New Islington Canal Lock 3 improvement options – Version 2

This document has been prepared by TfGM as a follow up to the meeting with MCC and the Canal and Rivers Trust and reflects the discussions at that meeting and the subsequent Disability Design Reference Group site visit.

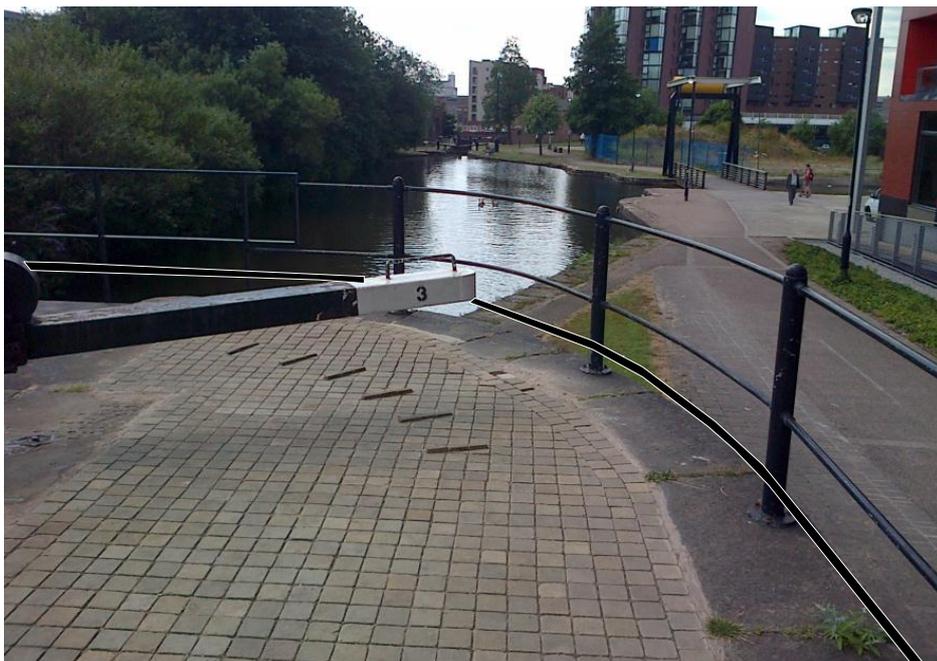
1. Tapping rail to existing railing

Provide a lower rail to act as a tapping rail for visually impaired pedestrians (which would also fill in the current gap between lower rail and bridge surface).
